## **EXHIBIT C**

UNITED STATES PATENT AND TRADEMARK OFFICE

APPLICATION NO.	FILING DATE	FIRST NAMED INVENTOR	ATTORNEY DOCKET NO.	CONFIRMATION NO.
09/814,828	03/23/2001	Sai Chang Yun	8733.246.00	4728

**Office Action Summary**

Figure 6

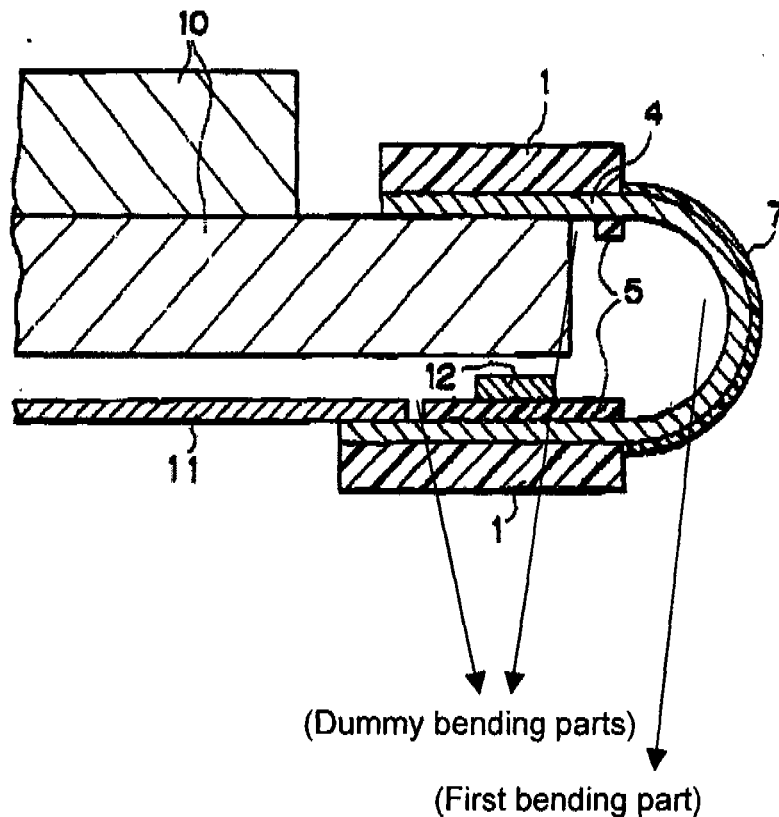
5. Claims 5 and 9 are rejected under 35 U.S.C. 102(b) as being anticipated by Tagusa et al. U.S. Patent 5,668,700 A.

Tagusa et al. discloses A tape carrier package, comprising; a pad part for connection to a liquid crystal panel; a base film mounted with an integrated circuit chip 1 for applying a signal to the liquid crystal panel; and a dummy bending part, for distributing a stress applied to the liquid crystal panel according to a thermal expansion of the pad part by removing a portion of the base film between the pad part and the

integrated circuit chip 1. The tape carrier package further comprises a second pad part for connection to a printed circuit board (see figure 6).
